ENGINE - FUEL AND CONTROL - FUEL TUBES - INTRODUCTION OF SMALLER CLIP AT CLIPPING POINT  
7031 - CATEGORY CODE 6 - MOD.ENG-73-0066

V2500-ENG-73-0066

Location of clip at clipping point 7031  
Fig.1

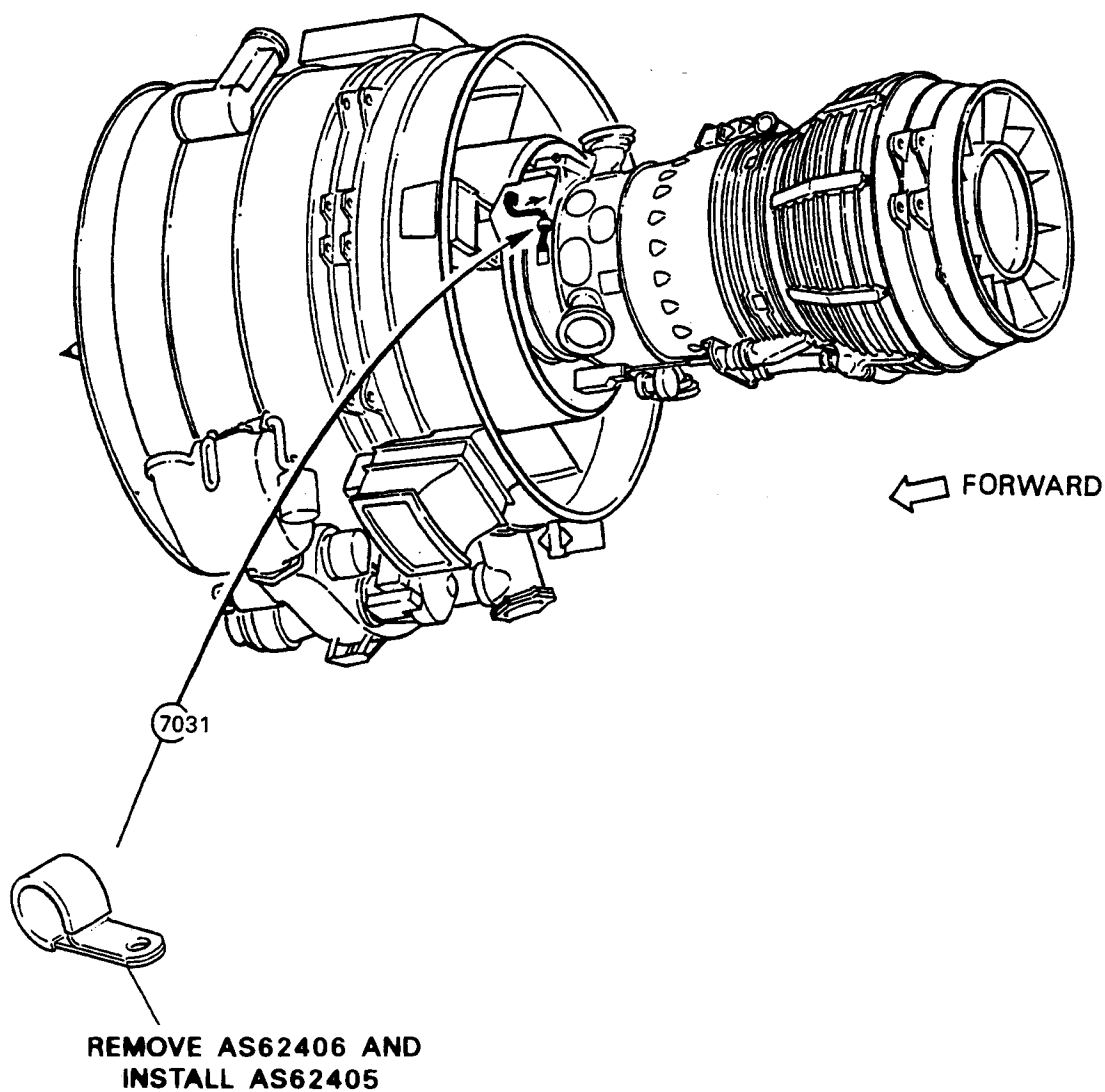
During assembly it was highlighted that the clip currently installed at clipping point 7031 is too large to make sure the Bleed Valve Actuator Master to disconnect fuel pipe is correctly secured.

A smaller clip replaces the existing clip at clipping point 7031.

- (1) Remove the AS20624 nut and 4W0133 bolt, disassemble clipping point 7031 sufficiently to remove AS62406 clip. Refer to Figures 1 and 2.

- (1) Assemble existing clipping point 7031, using new AS62405 clip, existing AS20624 nut, 4W0133 bolt and hardware. Refer to Figures 1 and 2.
- (2) Torque the nut to 36 to 45 lbfin (4 to 5 Nm)
